Monthly Specification Update

Intel® Server Boards S5500HV

Intel® Server System SR1670HV

Intel Order Number E77965-001

1. One power connector pin-outs definition in TPS is not correct

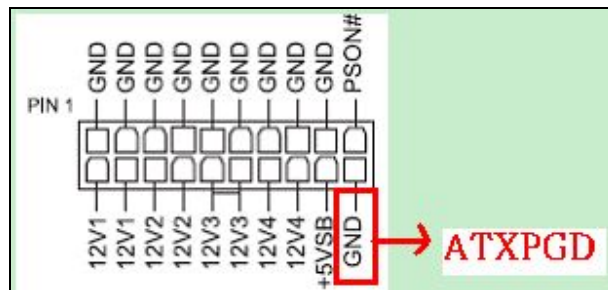
One power connector pin-outs definition is not correct,

Please refer below revision

This correction will be implemented in next TPS revision 1.1.
